Supplemental Staff Report for 7206 Meadow Lane Preliminary Plan 120100270

Location: Located in the northwest quadrant of the intersection of Meadow Lane and Oak Lane
 Zone: R-60
 Master Plan: Bethesda/Chevy Chase
 Property size: 1.33 acres
 Application to subdivide 1.33 acres of land into two lots for two one-family detached dwellings.
 Applicant: CC Green Vision, LLC
 Filing date: April 8, 2010

7206 Meadow Lane Preliminary Plan 120100270

Proposed Easement Boundary

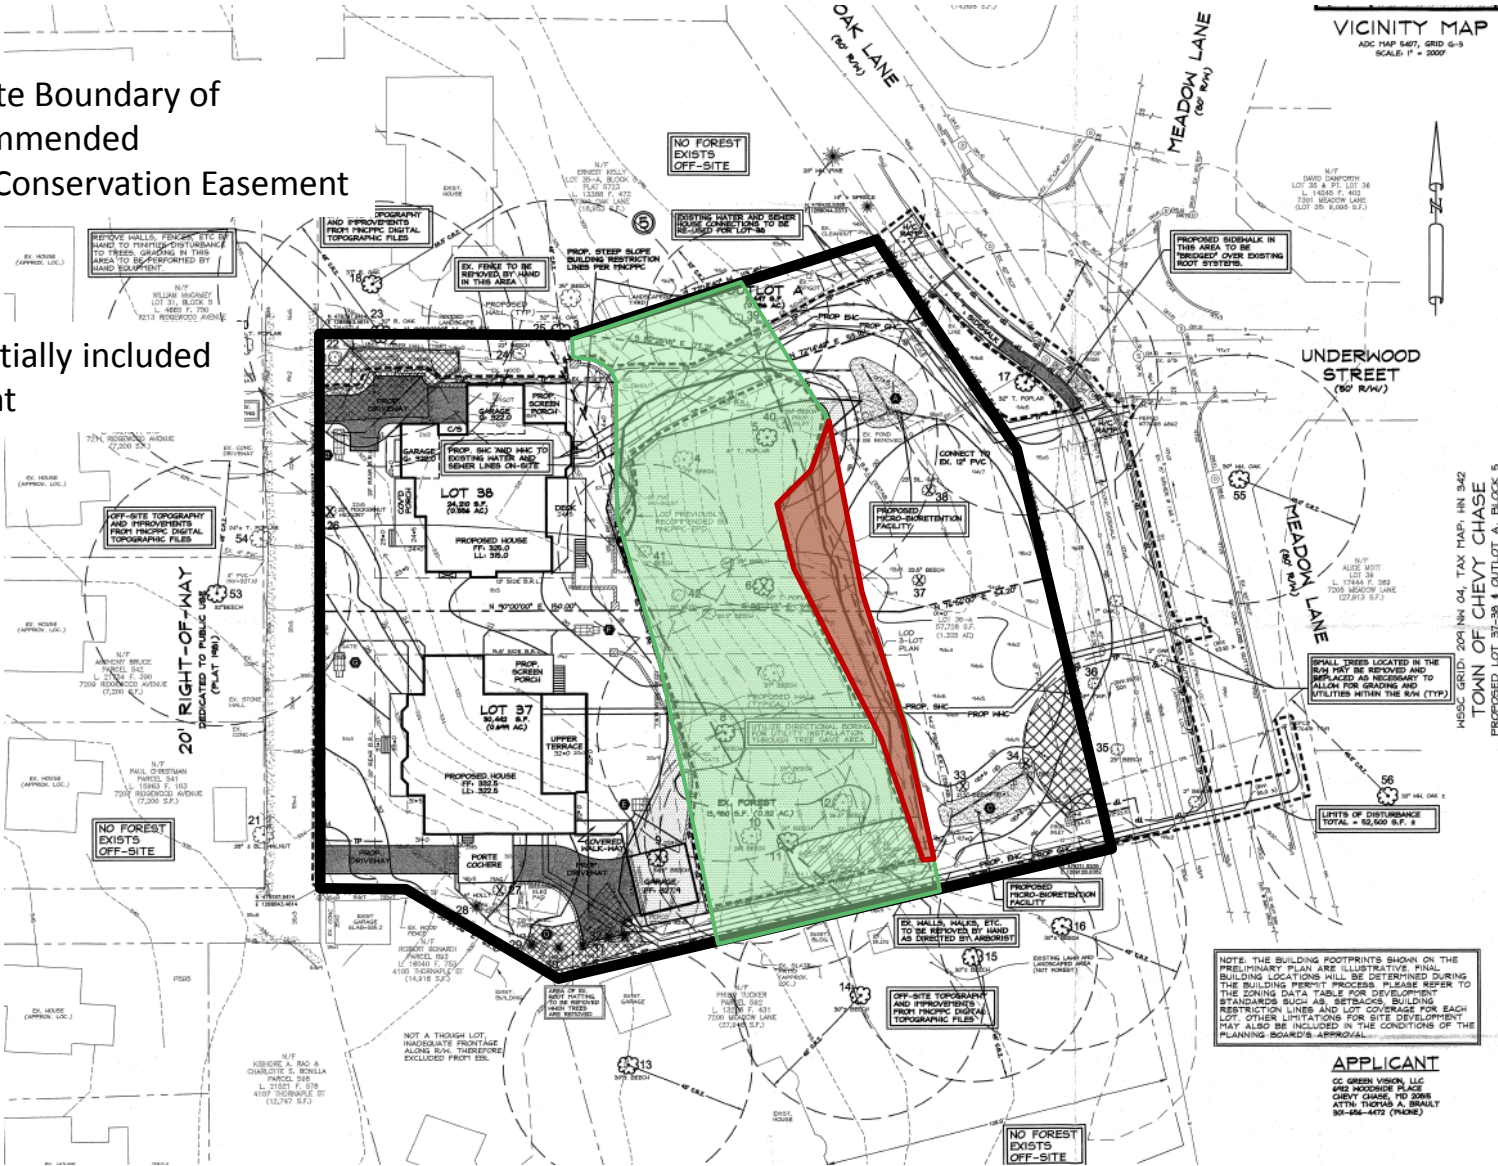
Must contain at least 10,000 SF of retained/planted forest

Approximate Boundary of Staff-Recommended Category I Conservation Easement

PROJECT: 7206 MEADOW LANE
 TOWN OF CHEVY CHASE
 PROPOSED LOTS 37-38 & OUTLOT A, BLOCK 5
 PLAT 5723, CIRCA 1959
 MDCS GRID: 209 NH 04, TAX MAP: HN 342
 BETHESDA (7TH) ELECTION DISTRICT
 MONTGOMERY COUNTY, MARYLAND
PRELIMINARY FOREST CONSERVATION PLAN AND TREE SAVE PLAN

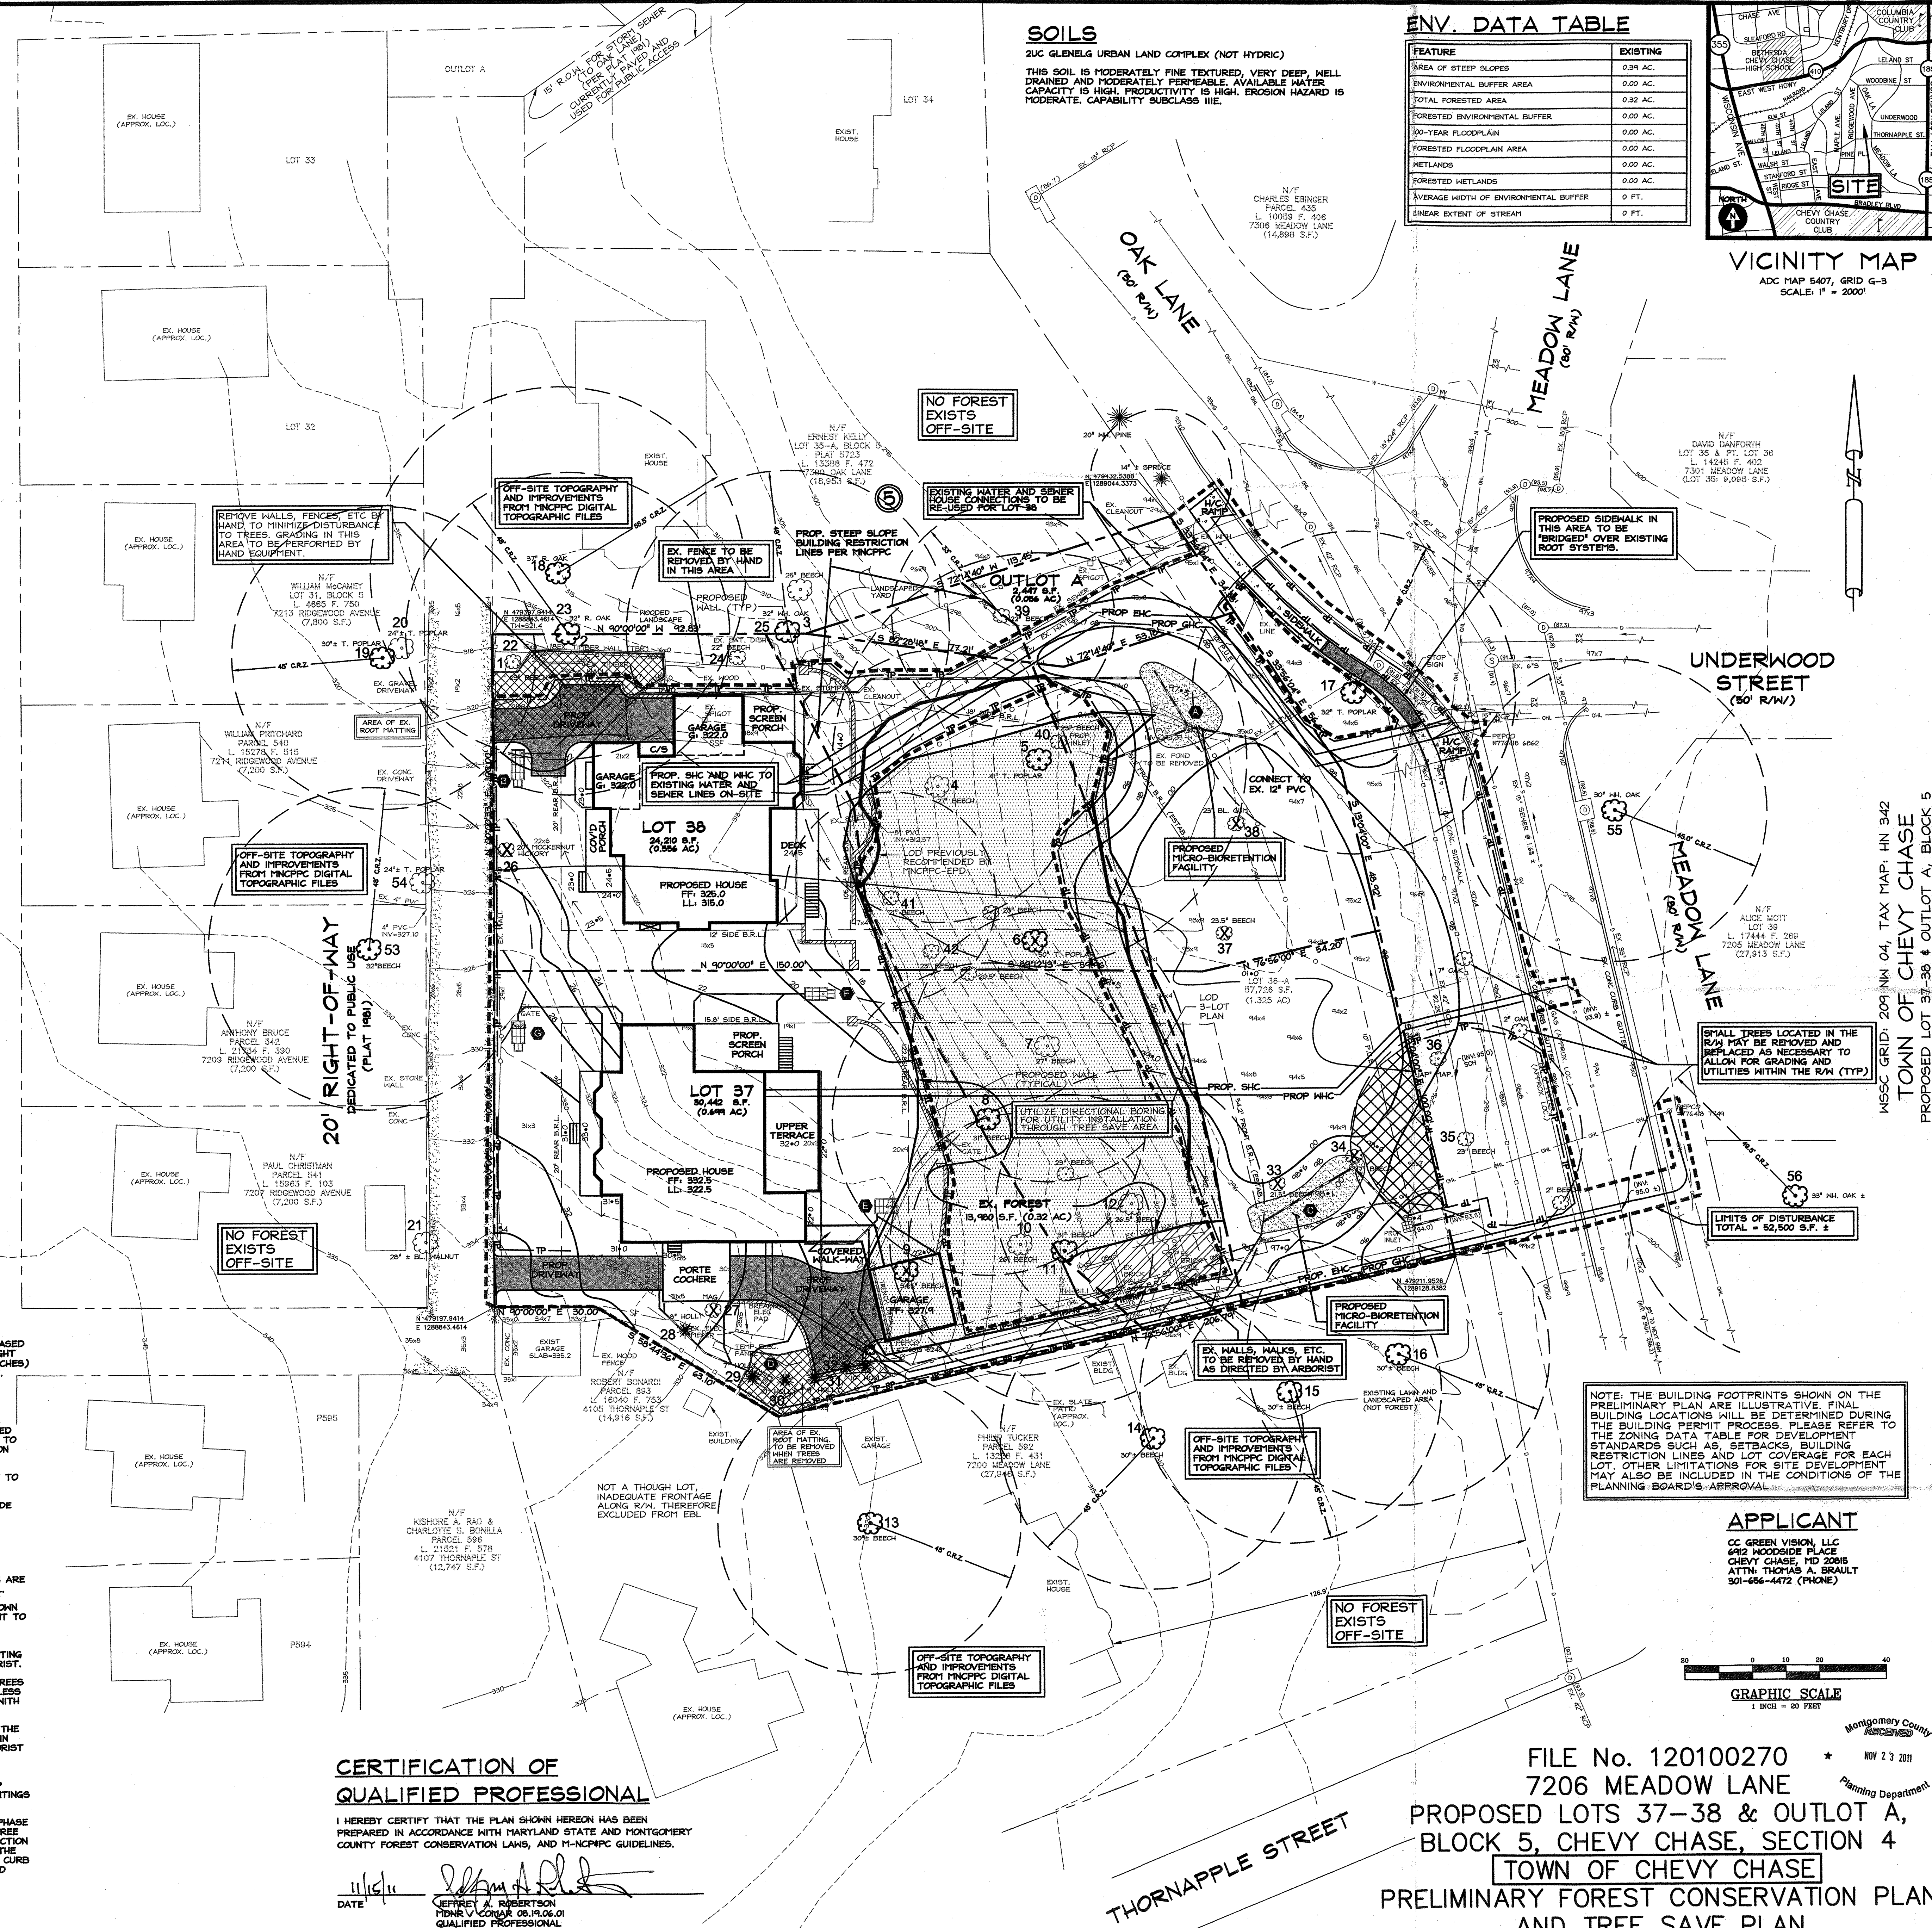
- a. Show a Category I easement, as modified by the proposed easement document, over the steep slopes and associated large trees.
 - b. Revise the plan, worksheet, notes, tables and legend to reflect the forest retained and/or planted in the modified Category I Easement.

- c. Include a provision to install all underground utilities for proposed Lot 38 and Outlot A by directional boring to be performed in manner minimizing any disturbance to the roots of saved trees. Air spading (instead of boring) may be performed in areas outside of the forest boundary.

- d. Revise the legend symbols and plan views for existing vs. proposed root protection matting so they match actual existing and proposed conditions.

- e. Delete miscellaneous tree note #1.
 - f. Provide appropriate plan notes for the careful removal of tree #6, and update miscellaneous tree note #2 accordingly.

- g. Revise miscellaneous tree note #7 (regarding tree #17) to retain tree protection fencing at the curb line throughout construction and install additional fencing along the proposed sidewalk edge. Alternately, temporary root protection matting can be used instead of installing fencing in the street right-of-way.

- h. Remove the plan note and graphics related to "LOD previously recommended by M-NCPPC-EPD" or show the LOD which was actually recommended by M-NCPPC.

- i. Shift the LOD away from tree #2/23 to an east-west line that is no closer than 15' from the tree.
- 3) Prior to any clearing, grading, demolition, or issuance of any building permit, the applicant must submit for review and obtain approval of a Final Forest Conservation Plan (FFCP). Specific conditions include:
